Re: NW Natural Comments on Proposed Explanation of Significant Differences  
 Portland Harbor Superfund Site

NW Natural appreciates the opportunity to submit these comments on EPA's *Proposed Explanation of Significant Differences, Portland Harbor Superfund Site, Portland, Oregon* (October 2018). We are pleased that EPA has moved quickly to incorporate its updated *Toxicological Review of Benzo(a)pyrene* (January 19, 2017) into the Portland Harbor Record of Decision before significant resources were spent implementing outdated cleanup values. We do, however, have some concerns about the proposed ESD, and we request that EPA modify the proposed ESD to be consistent with the remedy selected in the Record of Decision for the Portland Harbor Site.

Post Construction SWACs RAO 1 – EPA App J 0.5 RM - West Side

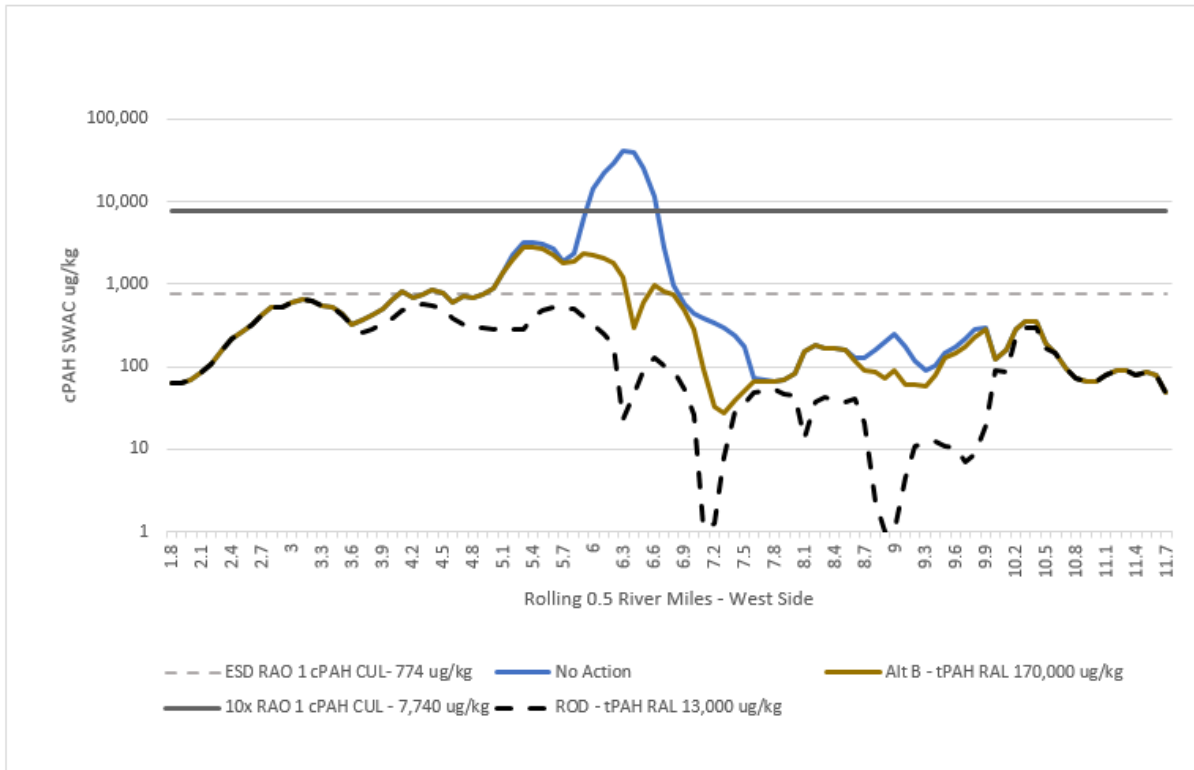
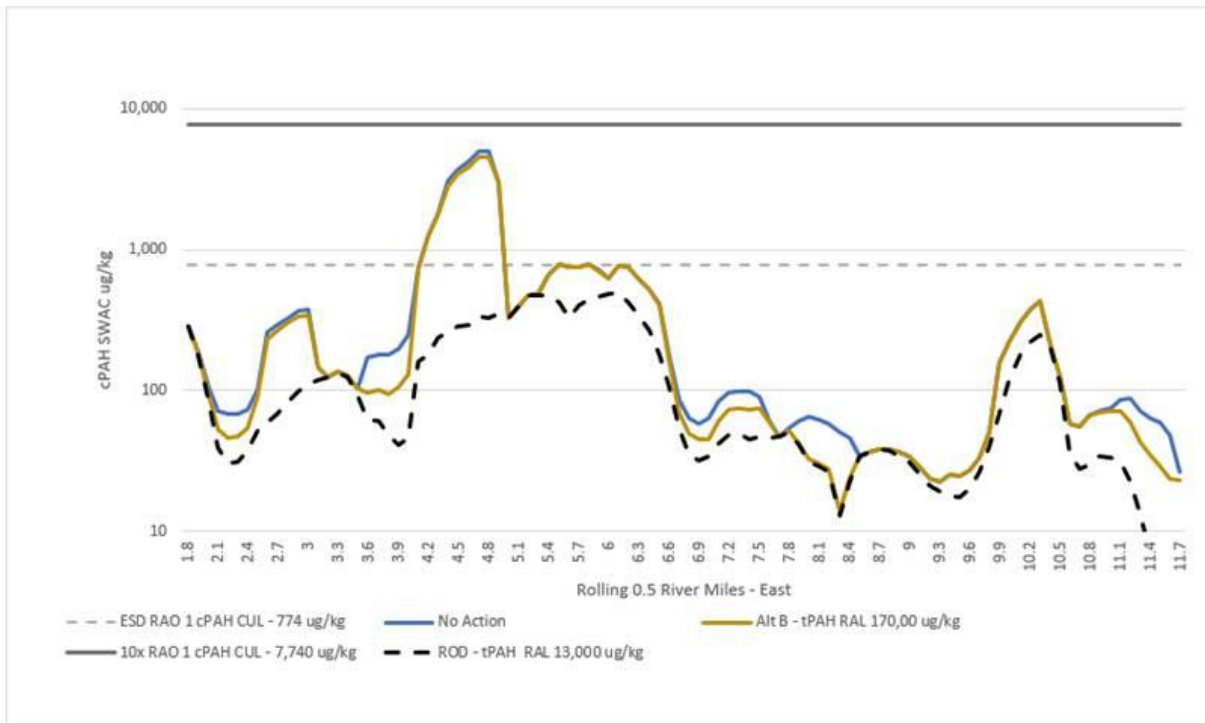
The proposed ESD did not evaluate any alternative PAH RALs against the interim target of  $1 \times 10^{-5}$  post-construction cumulative risk. If EPA intended merely to update its selected remedy consistent with the IRIS update, EPA, at a minimum, should have compared cumulative risks using PAH SWACS calculated for all alternatives evaluated in the FS against the interim targets adopted in the ROD. Instead, EPA simply compared post-construction cPAH SWACs to the updated cPAH cleanup level. ROD Appendix IV Table J2.2-1c readily shows that a PAH RAL as high as 170,000  $\mu\text{g}/\text{kg}$  (FS Alternative B) would reduce cPAH concentrations below  $1 \times 10^{-5}$  (7,740  $\mu\text{g}/\text{kg}$ ) in all nearshore half-river miles. The figures below, modeled after proposed ESD Figures 4a and 4b, show this graphically.<sup>23</sup>

Indeed, as ROD Appendix IV Table J2.2-1c shows, only seven half-river miles exceed 7,740 µg/kg at the “no action” (Alternative A) condition, and many areas identified for active remedies based on PAH RALs in the ESD would meet or approach the final cPAH cleanup level at PAH RALs significantly higher than the RAL selected in the proposed ESD.<sup>24</sup> Proposed ESD Figure 8, for example, shows an area of active remedy defined by the proposed 30,000 g/kg PAH RAL at approximately RM 3.8W; according to ROD Appendix IV Table J2.2-1c, all west bank half-river miles downstream of RM 4W already meet the final cleanup level at the “no action condition.”<sup>25</sup>

*Requested revision: EPA's June 2016 FS evaluations demonstrate that nearshore PAH RALS as high as 170,000 µg/kg would meet the ROD interim target for RAO 1 of  $1 \times 10^{-5}$  throughout the site.<sup>32</sup> Revising the PAH RALS proportionally to the updated cleanup levels would be consistent with the FS and the ROD, which explicitly incorporate MNR as a component of RAO 1 remedies.*

Post Construction Clam Consumption Risk  
RM 4-7 Whole River Miles  
Log Scale

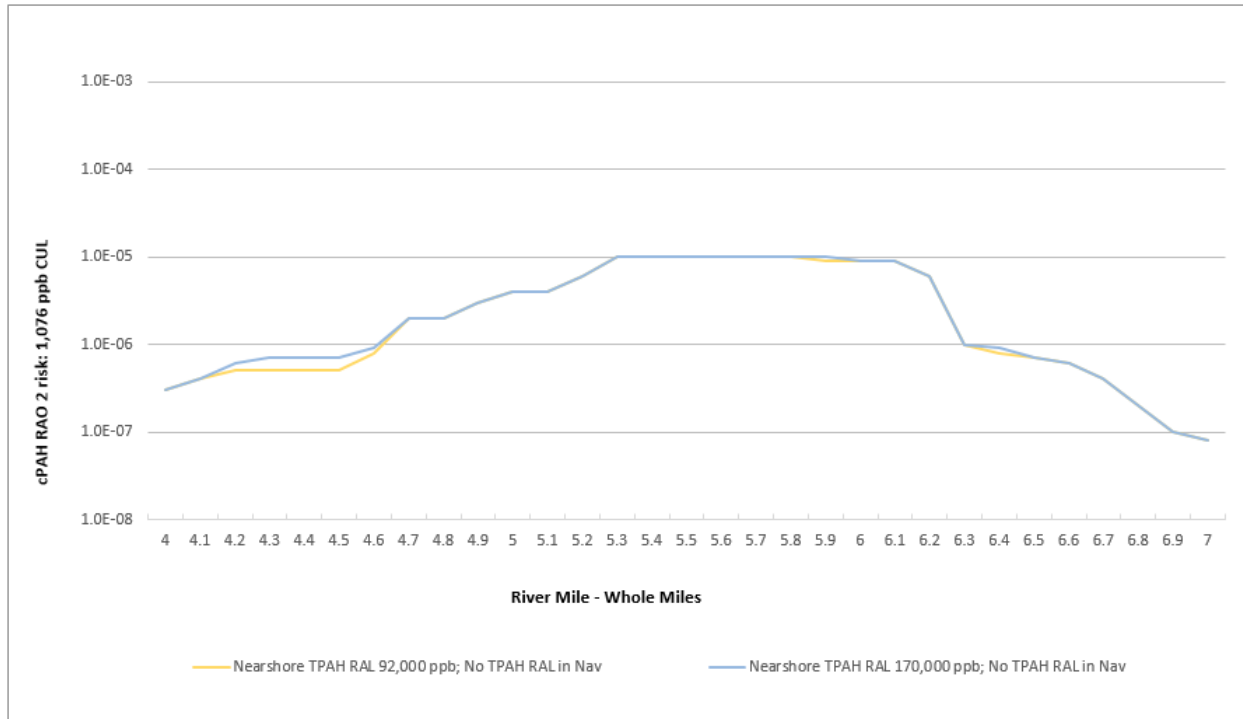
In fact, EPA’s calculation of sitewide cPAH concentrations at the “no action” condition (1489.1  $\mu\text{g}/\text{kg}$ )<sup>40</sup> would yield risks calculated using the updated cleanup level (1,076  $\mu\text{g}/\text{kg}$ ) of  $1 \times 10^{-6}$ , using the same rounding conventions as the ROD. Certainly, cPAH risks, if any,<sup>41</sup> are so far below the interim target of  $1 \times 10^{-4}$  that they contribute little, if anything, to attainment of the interim target. As shown in the figure below, cleanup in nearshore areas to even the least conservative PAH RAL considered in EPA’s FS (170,000  $\mu\text{g}/\text{kg}$ ) would result in potential risks from clam consumption well below the interim target as calculated on the whole river mile scale evaluated in the BHHRA without any active PAH cleanup in the navigation channel.<sup>42</sup>

Again, EPA appears to have determined that natural recovery has no role in addressing cPAH risks associated with shellfish consumption, but only for cPAHs and for no other chemical presenting unacceptable risk at Portland Harbor.<sup>43</sup> Such a decision would amount to a fundamental change to a basic feature of the ROD and must be made by a ROD amendment, subjected to evaluation of the nine remedy selection criteria, and adequately explained.

*Requested revision: EPA's ROD is flexible enough to support the use of institutional controls in place of dredging or capping based upon land use.<sup>44</sup> The ESD could confirm the findings of the EPA risk assessment that clam harvesting is unlikely to occur in deep water areas and state explicitly that institutional controls could be used to prohibit harvesting of any clams that may be present within the navigation channel, obviating the need for expensive and disruptive dredging on the basis of this hypothetical and undocumented exposure pathway.<sup>45</sup>*

Figure 4.2-8b. Predicted surface water cPAH concentration reductions.

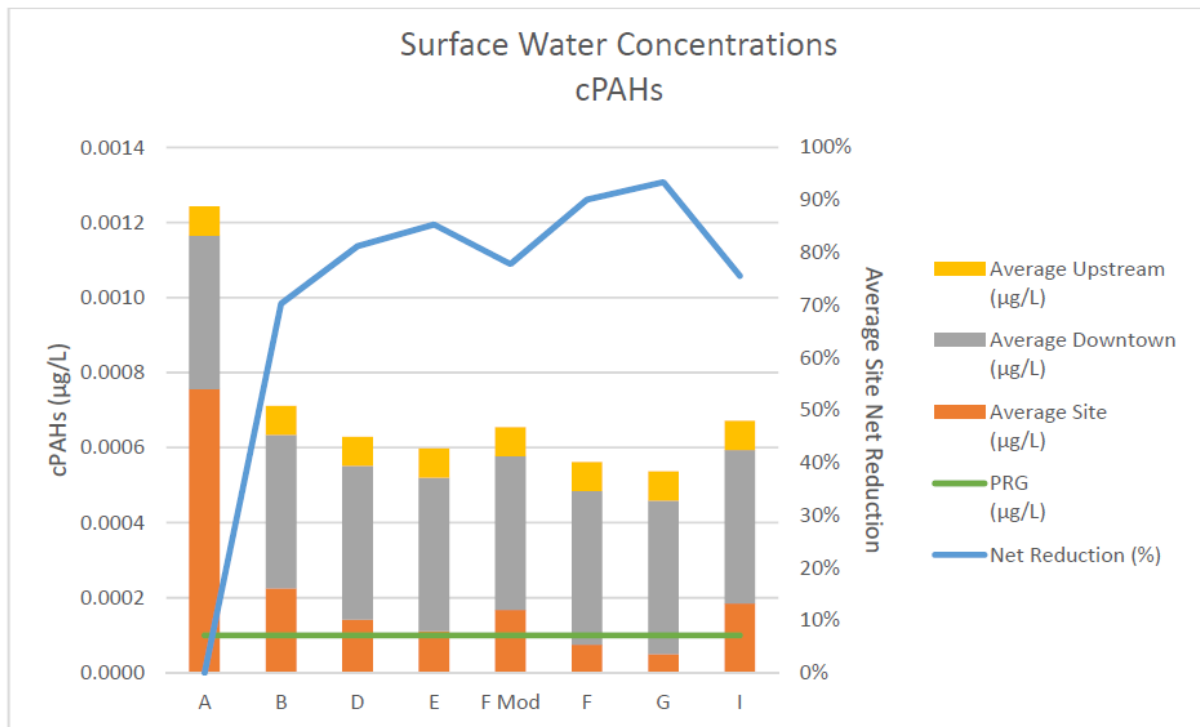
In the ROD, EPA evaluated protection of human health risk related to surface water (RAO 3) against an interim target of 10 times the cleanup level.<sup>47</sup> EPA calculated maximum predicted cPAH surface water concentrations at the “no action” level at just over .0012 µg/l.<sup>48</sup> EPA has calculated the average Site cPAH concentration at “no action” at 0.0008 µg/l.<sup>49</sup>

This is below the Oregon water quality standard.

ROD Table 17 sets the cPAH surface water cleanup level at .00012 µg/l based not on the Oregon water quality standard but on the National Recommended Water Quality Criteria for benzo(a)pyrene. NRWQC are not applicable to CERCLA cleanups but may be relevant and

appropriate at some sites. EPA guidance provides, “Prior to using an FWQC for a particular constituent, RPMs should consult the IRIS data base ... to ensure consideration of the latest available scientific information.”<sup>50</sup> The .00012 µg/l benzo(a)pyrene NRWQC, which is based on outdated cancer slope factors, no longer represents good science and is no longer relevant or appropriate to RAO 3 (reduce cancer and non-cancer risks to people from surface water at the site).<sup>51</sup>

*Requested revision: EPA should update the cPAH cleanup level in ROD Table 17 to the applicable Oregon water quality standard. Because EPA’s analysis shows this standard is met at the no action level, no PAH cleanup is necessary to meet RAO 3.*

RAO 5 10x areas

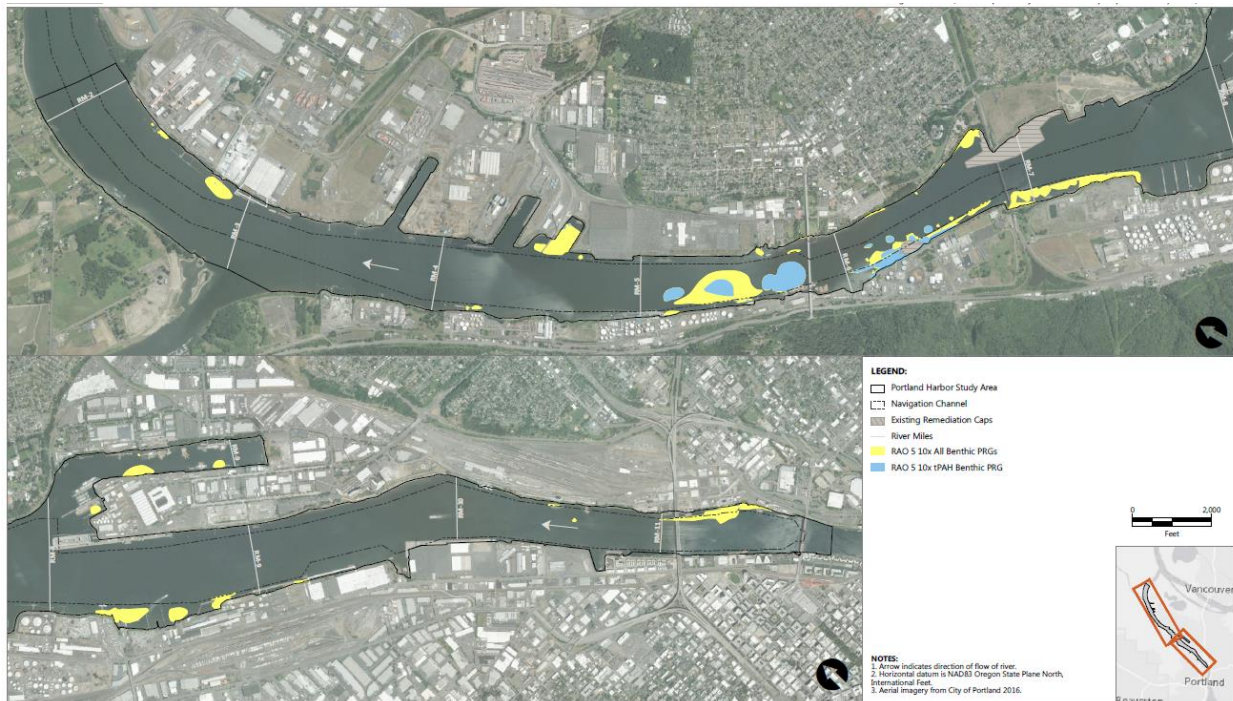
The effect of this fundamental change is to require petroleum cleanups to assume a grossly disproportionate share of the burden of addressing RAO 5 among the 87 chemicals determined to present potentially unacceptable risk to benthic invertebrates. Using surfaces generated consistent with EPA ROD methodology, we calculate a total of 117 acres exceed 10 times the RAO 5 cleanup levels for all chemicals. Our mapping shows that approximately 30 acres of the site exceed the 10x RAO 5 PAH cleanup level (approximately 26% of the 117 total acres).

Under the proposed ESD, which would apply PAH RALs ranging from 30,000  $\mu\text{g/kg}$  to 170,000  $\mu\text{g/kg}$ , active remedies will address 69% of the 117 acres exceeding 10 times benthic cleanup levels, or about 81 acres.<sup>62</sup> PAH RALs would therefore remove 37% (30 of the 81 acres) of the benthic risk area addressed by active remedies, even though PAHs are responsible for only 26% of the total area exceeding 10 times the RAO 5 PRGs. Put another way, using the RALs in the proposed ESD, active petroleum remedies would remove approximately 124% of the PAH share of the RAO 5 interim target. This may be EPA's strategy for mitigating benthic risk presented by chemicals other than PAHs, but if so EPA should state so explicitly and explain its decision that the burden of this remedy should fall on petroleum sources.

*Requested revision: EPA should not apply PAH RALs in the navigation channel on the basis of RAO 5. The existing ROD contains the flexibility to allow for delineation during remedial design of areas where RAO 5 is driving cleanup based on the multiple lines of evidence, including toxicity testing, used in the BERA.<sup>66</sup> For all of the reasons discussed above, protection of benthic invertebrates is the only potential basis consistent with the baseline risk assessment for active PAH remedies in the navigation channel. At a minimum, the proposed ESD should clarify that, during remedial design, active remediation of benthic toxicity areas in the navigation channel may be defined using the multiple lines of evidence approach rather than through strict application of PAH RALs.*
